SUBJECT: CALLAWAY PLANT, UNIT 1 - REQUESTS FOR RELIEF PR-01 THROUGH PR-06, ALTERNATIVES TO ASME OM CODE REQUIREMENTS FOR INSERVICE TESTING FOR THE FOURTH PROGRAM INTERVAL (TAC NOS. MF2784, MF2785, MF2786, MF2787, MF2788, AND MF2789)

SAFETY EVALUATION BY THE OFFICE OF NUCLEAR REACTOR REGULATION

CALLAWAY PLANT, UNIT 1

Figure 1

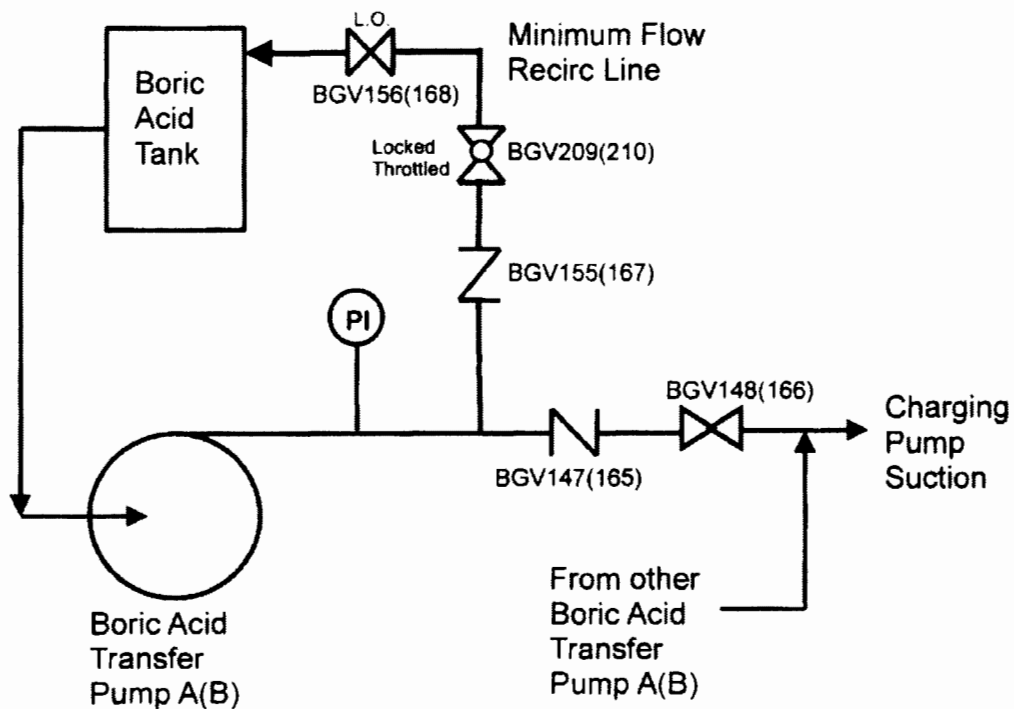
The normal test loop for the boric acid transfer pumps is suction from the boric acid tank and discharge through a mini-flow recirculation line back to the boric acid tank. There is no flow measuring instrumentation installed in this flow path. The mini-flow recirculation line has a locked throttle valve BGV209(210) that is set to allow for a minimum pump recirculation flow of approximately 15 gallons per minute (gpm). This throttle valve allows minimum recirculation flow to protect the pump and allows adequate flow to the charging system to allow for immediate boration in emergency conditions. Adjusting the throttle valve for the quarterly IST could potentially allow for the mis-positioning of the valve and could potentially have an adverse effect on the system's capability. Since the locked throttle valve will not be adjusted, the test loop is considered to be a fixed resistance flow path.

As an alternative to measuring differential pressure and flow during the Group A quarterly test, only the differential pressure will be measured and compared to its reference value. Additionally, vibration measurements are also recorded and

compared to their reference values. The Group A test will be performed using the [minimum flow recirculation path] shown in Figure 1, with the throttle valve [BGV209(210)] remaining in its locked position. The reference value is approximately 112 psig at an estimated flow rate of 15 gpm. Because the system resistance is fixed and flow can be assumed to be constant, pump degradation may be detected by comparing successive measurements of pump differential pressure. Based on this, it is not warranted to install additional instrumentation to provide for flow measurement.

During the comprehensive inservice test when flow may be measured, full-spectrum vibration analysis will be performed which is beyond the vibration analysis required by the ASME OM Code. The vibration measurements will be recorded and compared to their reference values. Thus, when performing the comprehensive pump test, all required parameters will be measured and compared to their reference values. The performance of full spectrum analysis, in addition to continued quarterly and comprehensive testing, will ensure that an accurate assessment of pump health and operational readiness is determined.

Pump differential pressure and flow rate are two parameters that are measured and evaluated together to determine pump hydraulic performance. However, the minimum flow return lines at Callaway used for quarterly Group A testing of the boric acid transfer pumps are of fixed resistance due to the locked valves BGV209 and BGV210, do not provide the ability to vary flow rate, and are not instrumented for flow rate. As an alternative to measuring differential pressure and flow during the Group A test, the licensee proposed that only the differential pressure will be measured and compared to its reference value. The differential pressure reference value is approximately 112 psig at a flow rate of 15 gpm. Measurement of the boric acid pump differential pressure and a comparison to the reference value, along with vibration measurement during Group A testing, will provide assessment of the pump performance. This alternative request applies only to Group A testing of boric acid transfer pumps PBG02A and PBG02B.

In response to RAI PR-03-02 dated March 5, 2014, the licensee submitted pump curves for the boric acid transfer pumps. At a flow rate of 15 gpm for the proposed Group A test, there is slope in the pump curves, but not as much as at the comprehensive pump flow rate of 75 gpm. However, since the pump flow rate of 15 gpm is essentially fixed, pump degradation can be detected.

The NRC staff concludes that the licensee's proposed alternative to test the boric acid transfer pumps by measuring the differential pressure and comparing it to the reference value, as discussed above, provides an acceptable level of quality and safety.
